City of Mississauga Department Comments

Date Finalized: 2022-08-10	File(s): A194.21
To: Committee of Adjustment	Ward: 4
From: Committee of Adjustment Coordinator	Meeting date:2022-08-18 3:00:00 PM

Property Address: 580 Rideau Gate

Appendix 1 – Transportation and Works Comments

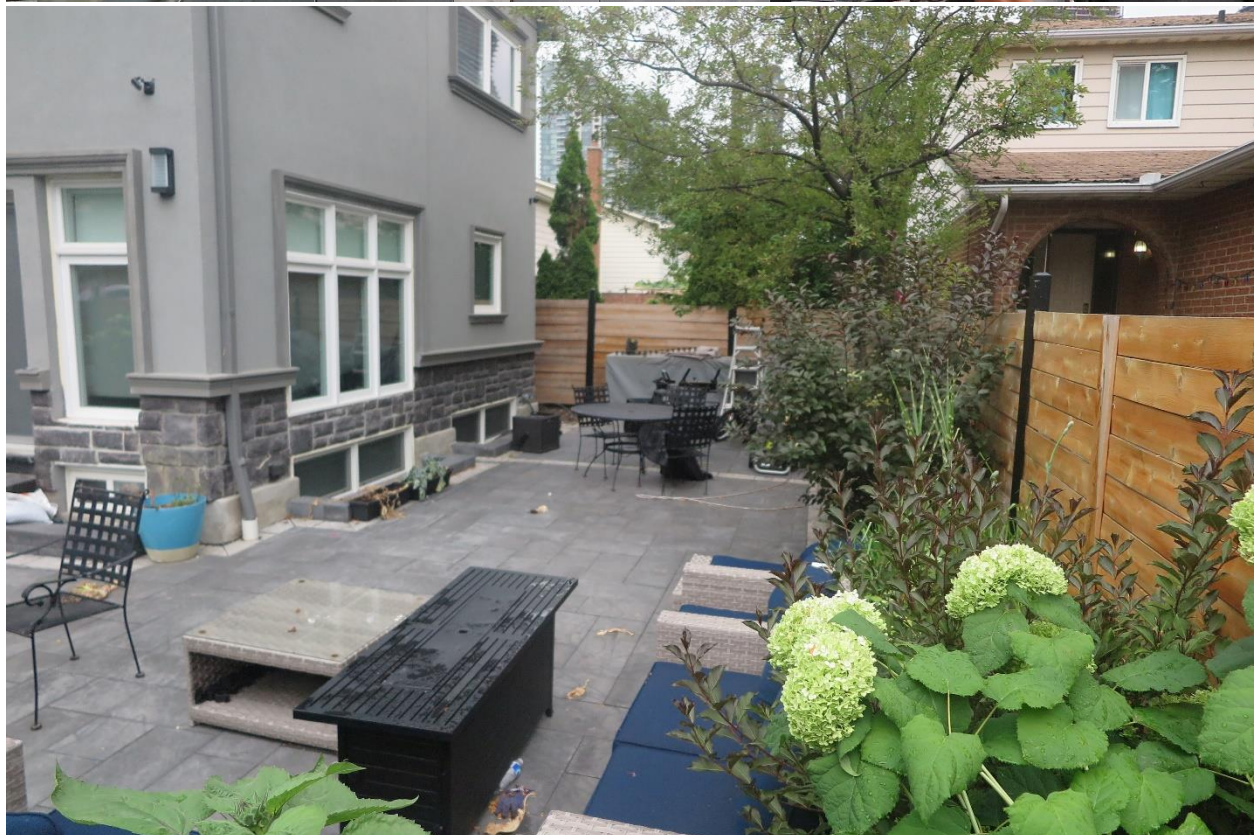
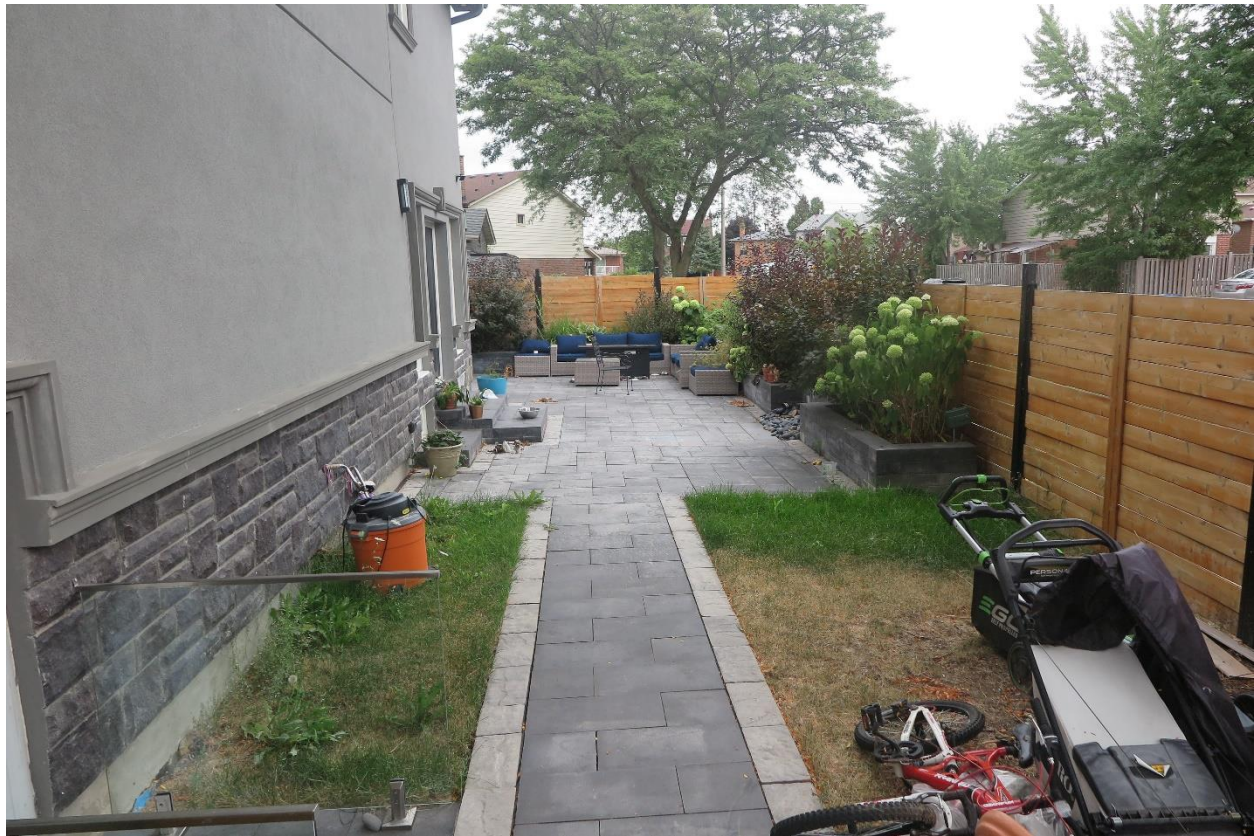
We have recently revisited the property on August 4, 2022 and are providing recent photos which are similar to the previous photos provided.

This department notes that with regard to the widened driveway within the municipal boulevard (the area between the municipal curb and property line) we would request that this area be reinstated with topsoil and sod should the application be modified to reflect a smaller driveway width within the subject property or if the application is not supported by the Committee.

With regards to the setback to the decorative paving in the rear yard we note that this is a corner lot and the drainage from the rear yard is directed towards the roadway (Tea Garden Circle). We also observed from our site inspection that if there was any drainage being directed to the abutting property, this drainage is redirected to Tea Garden Circle as the abutting neighbour has widened their driveway to the common property line. A photo depicting the neighbour's driveway has also been provided.

The file also contains a letter from 571 Rideau Gate indicating concerns with the water pooling on the sidewalk on Tea Garden Circle. We have also attached a photo of the sidewalk which may be in question and do note that it is broken and been marked with yellow spray paint. We are not sure if a request has been made to re-instate the broken sidewalk, however, if anyone did have a concern with this they should call 311 and register their concerns with the City to address the issue.
